Item C1

Applications for: (i) variation of conditions of permission MA/08/45 regarding revised proposals for Phase 1 slope remediation – MA/14/688 (KCC/MA/0103/2014); (ii) variation of condition 2 (working & restoration scheme) of MA/09/1013/MR108, a request for a temporary relaxation of condition 5 (extent of area outside agricultural use at any one time) and schemes submitted pursuant to conditions 14 (diversion of watercourse), 23 (archaeological work), 25 (compensatory habitat) & 29 (restoration & aftercare) – MA/14/689 (KCC/MA/0099/2014) at Lenham Quarry, Forstal Road, Lenham

A report by Head of Planning Applications Group to Planning Applications Committee on 22 October 2014.

Existing Site Layout within Phase 1 (including over steepened slope to south)

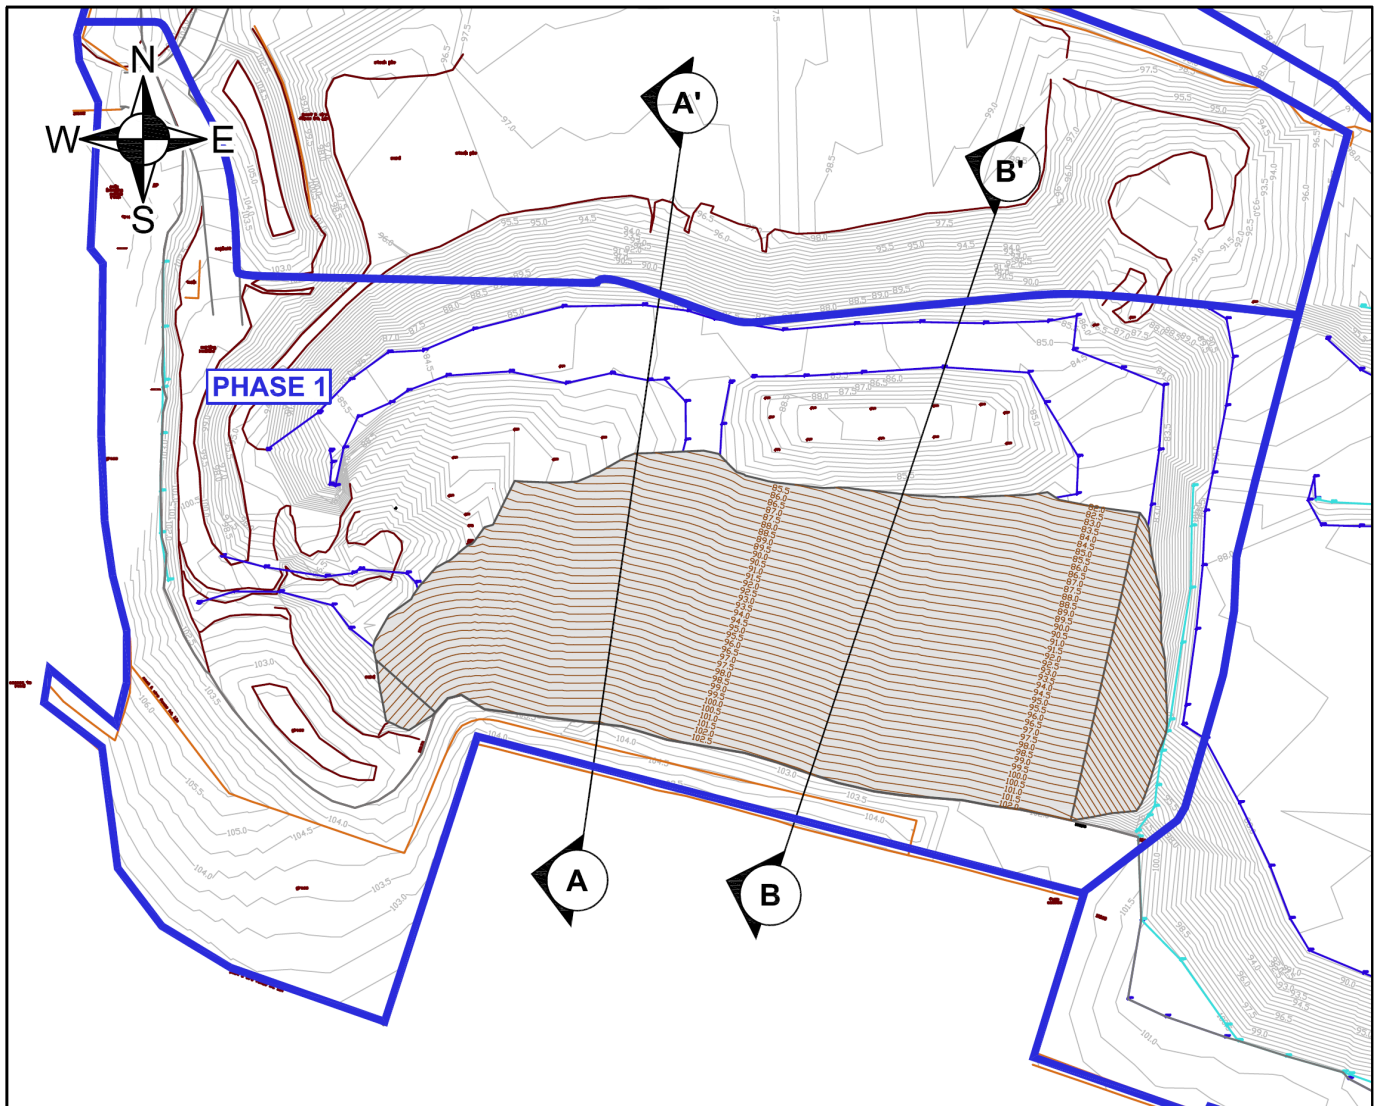
- Constructing the southern slope from imported clays would require a change to the approved slope design. To achieve long-term stability, the restored slope would need to be constructed at a shallower gradient at 1v:4h (1:4 slope), as opposed to the 1v:2h slope originally proposed. Please see proposed the proposed layout drawing and cross-sections included above. [Condition 6]

Cross Sections - indicating level changes to achieve revised 1v:4h slope

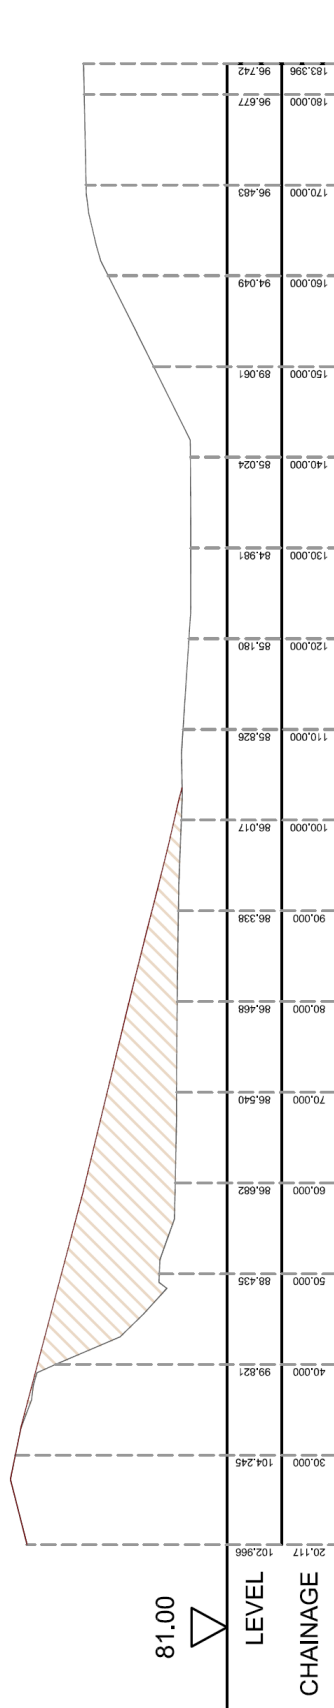
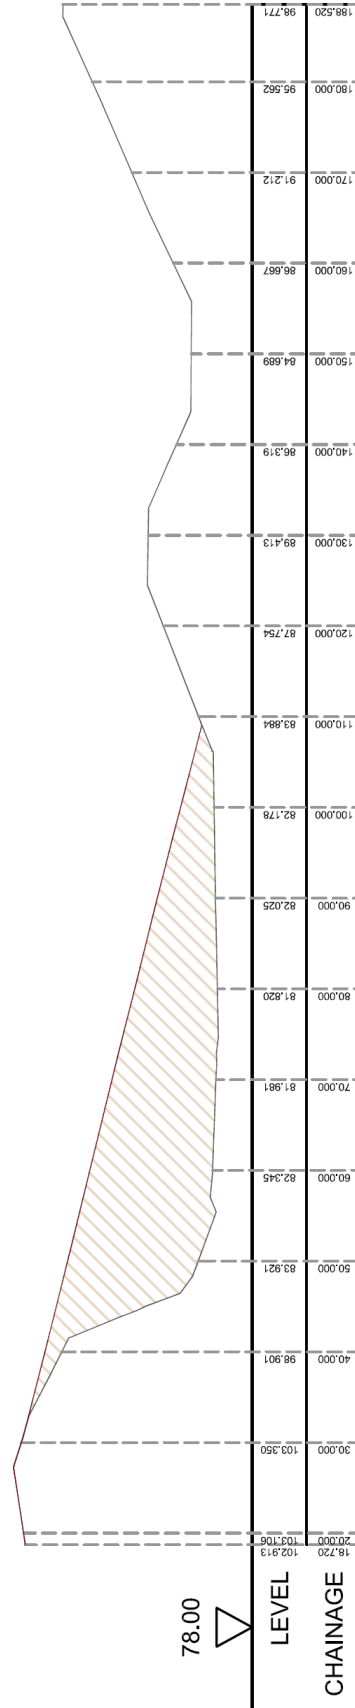
71. After examining the application and the supporting technical report, the County Council's geotechnical consultant has confirmed that the revised approach to the design of the slope would have an adequate factor of safety. He raises no objections to the application subject to the development being carried out in accordance with the proposed scheme and recommends that the existing geotechnical conditions imposed on permission MA/08/45 remain relevant and should be re-imposed on any new permission. These include only inert materials that are the environmental and engineering equivalent of on-site materials to be imported and the submission of annual and final geotechnical verification reports. It is also noted that the Environment Agency raise no objection to the application, confirming that the use of imported clay in place of inert granular fill materials would be acceptable from an environmental perspective.

Revised Scheme of Working, including retained and proposed soil bunds

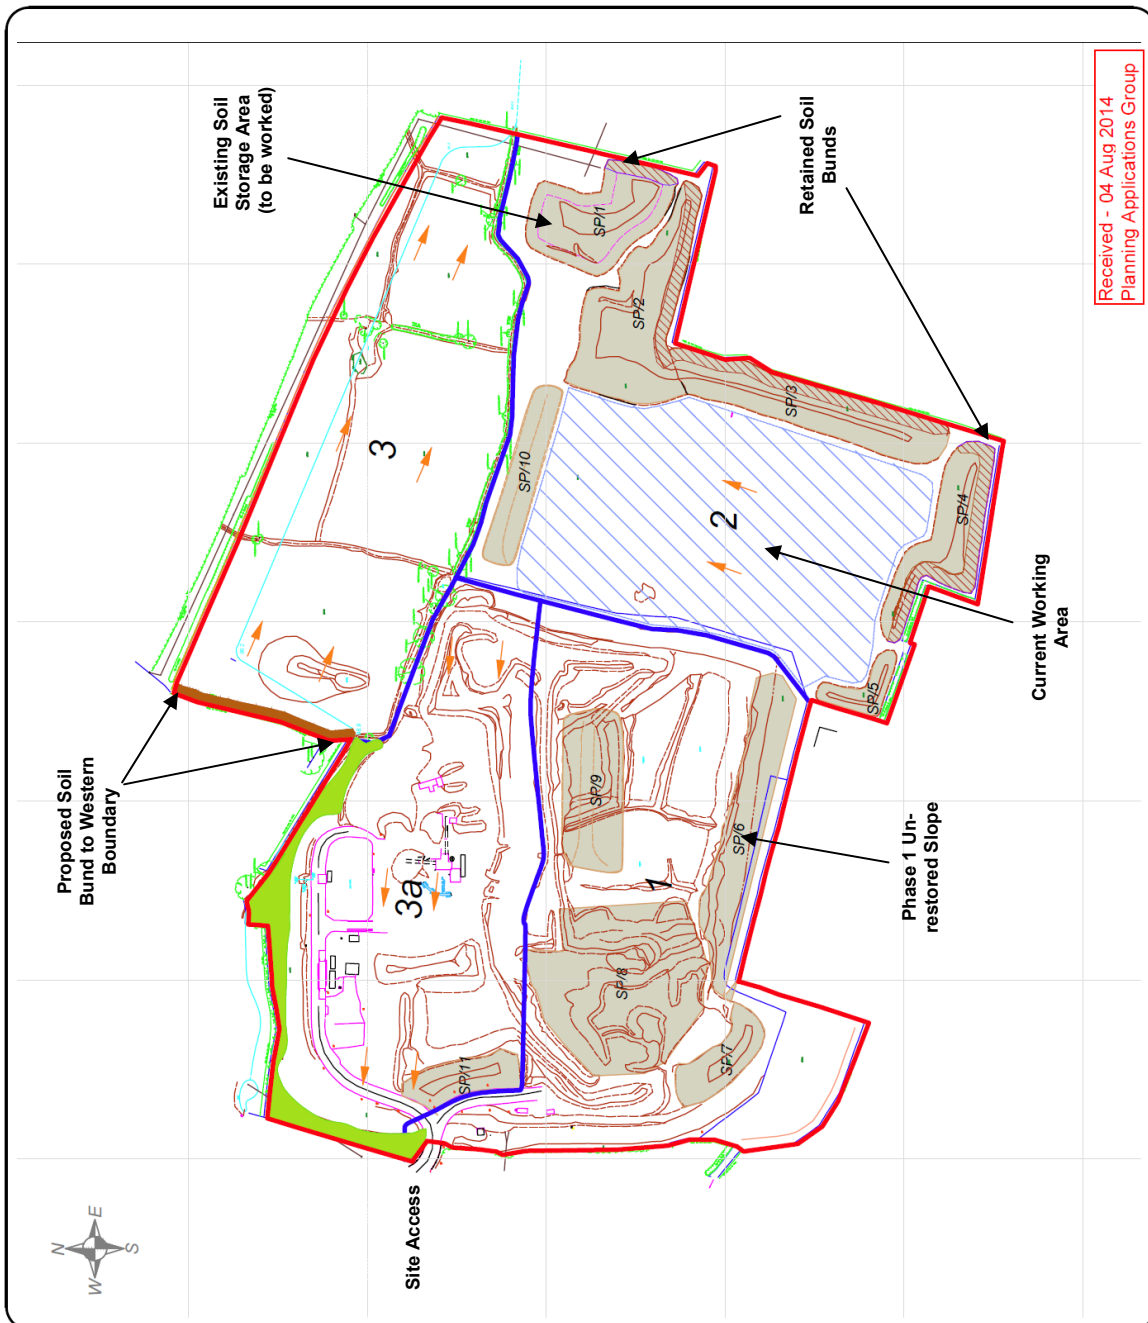
Mitigation measures for air quality (dust) must include those described in the revised 'Dust Assessment Addendum'. The location and features of the earth bunds must agree with those shown on drawing 'LEN 19 Rev B – Revised Scheme of Working' (included on page C1.11) and the site operated in accordance with the 'Revised Scheme of Working' dated July 2014.

The soil bunds *proposed* are expected to work as noise barriers and should be delivered and maintained in accordance with drawing 'LEN 19 Rev B – Revised Scheme of Working'. The construction of the 'new 2m high soil bund' on the western boundary of Phase 3 should be constructed before work commences on this phase of the quarry.

83. The 'Revised Scheme of Working' (and accompanying drawing LEN/19 included on page C1.11) have been updated at the County Council's request in order to address: details of the soil bunds to be retained / positioned as part of the noise and dust mitigation for Phases 2 and 3; a clearer indication of the timing of the restoration of Phase 1 in relation to the continued working and restoration of Phase 2 and the timing of commencement of operations in Phase 3; and an updated approach to the working of Phase 3 that takes account of the proposed approach to the permanent diversion to the existing water course (considered in paragraphs (96 - 101) below).

Watercourse Diversion and Gault Slope Profile (Phase 3)

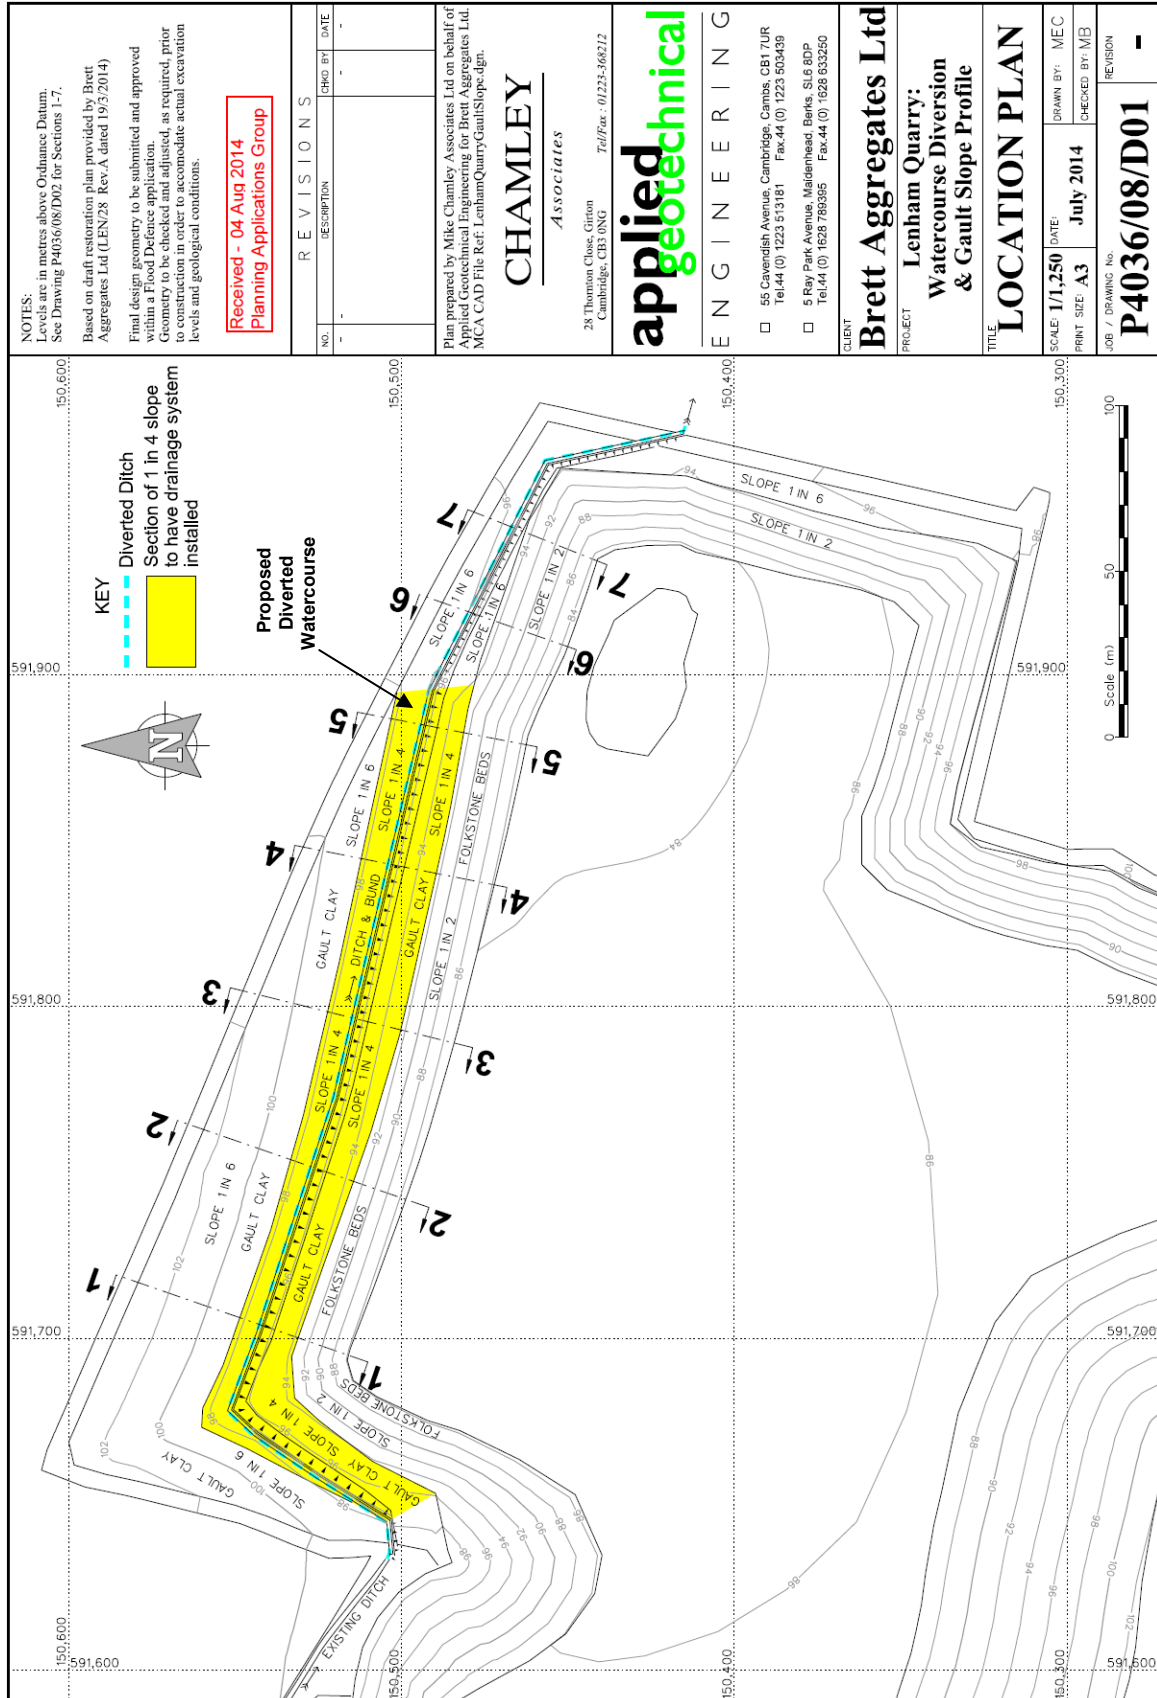
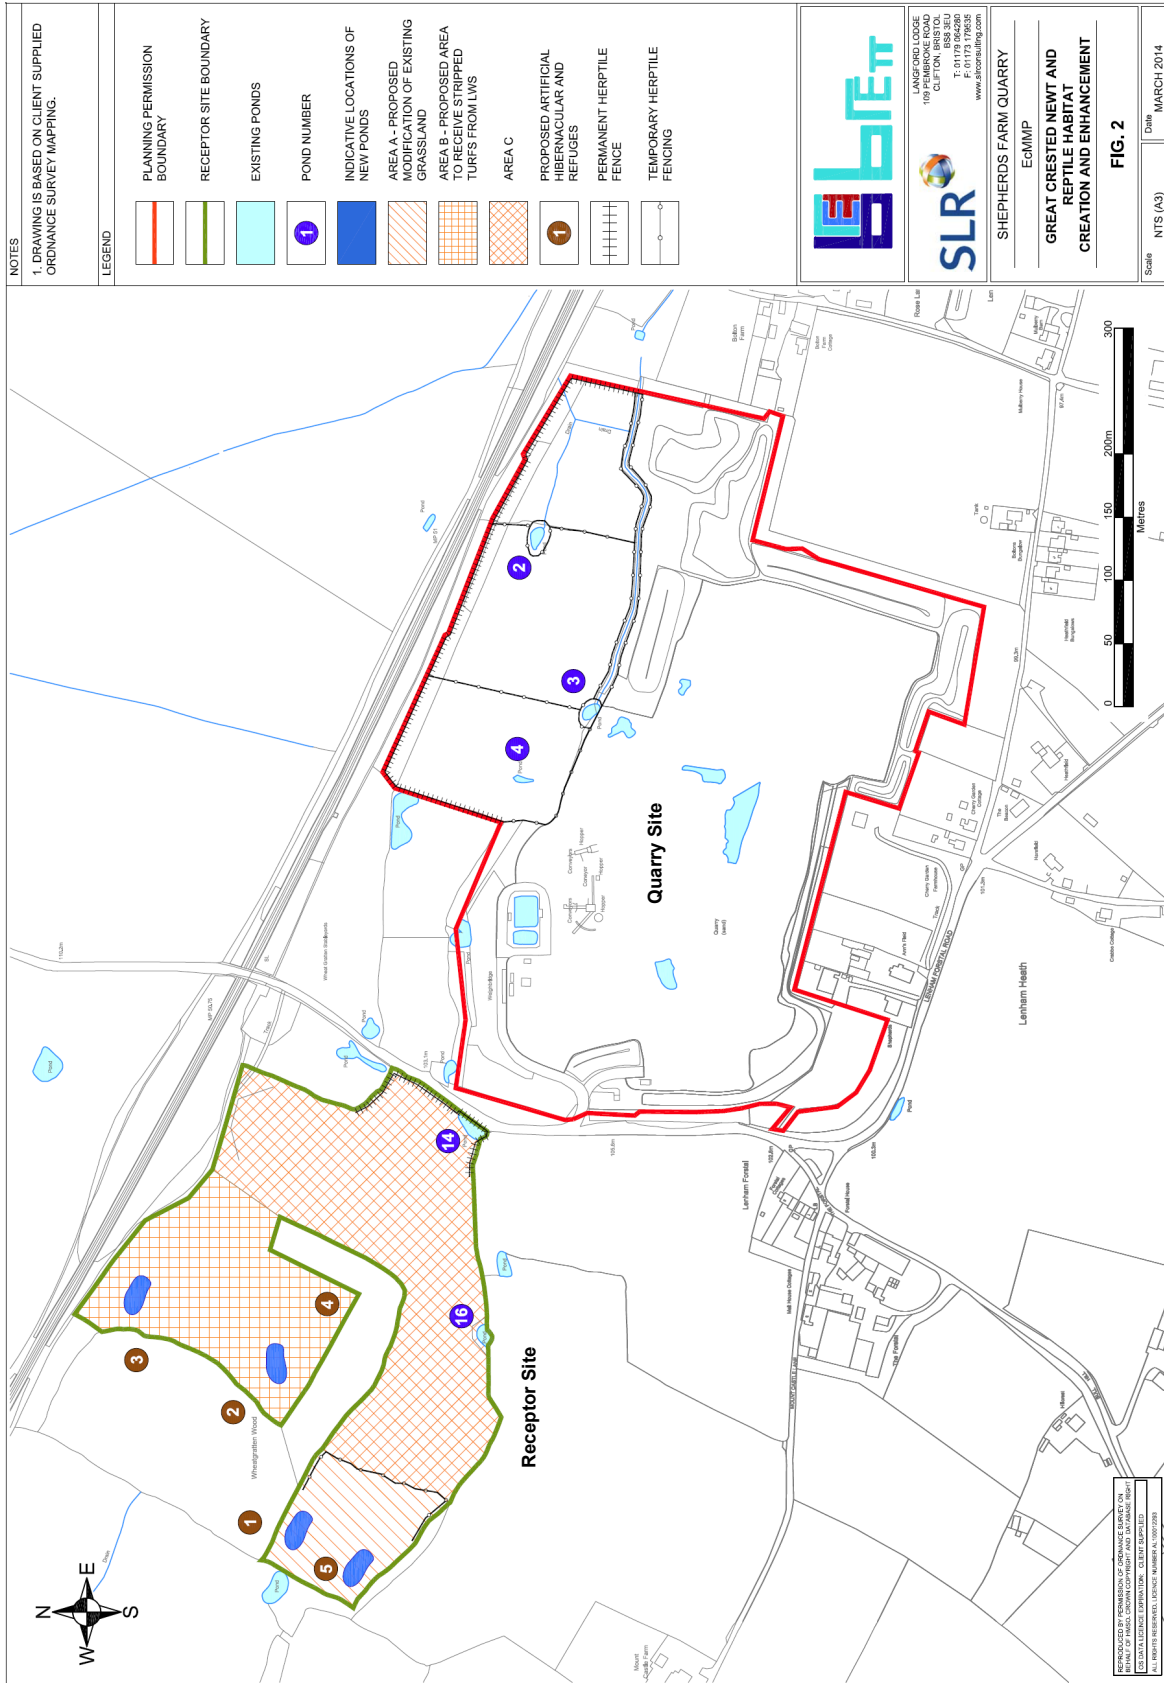
- A scheme of surface water management, including sustainable drainage and details of the permanent diversion of the watercourse on site. The submission proposes to divert the watercourse to an open gravity fed channel to be constructed as an embankment across part of the northern slope of Phase 3 of the quarry. See attached drawing on page C1.12.

101. Notwithstanding the concerns expressed by the local residents I am satisfied, having regard to the technical consultee comments, that the proposed scheme would be the most sustainable approach to the diversion of the watercourse and would maintain the necessary flow through the site to properties beyond. The proposed design and the revised approach to the working of Phase 3 of the quarry would preclude the need to temporarily divert the watercourse and enable the new channel to be constructed with a gradient that would allow the watercourse to flow without the need for a pump. The open channel would also present an opportunity to create a new habitat on site and ensure that the scheme can be easily maintained. I am therefore content that the submitted details satisfy the requirements of condition 14 and should be approved.
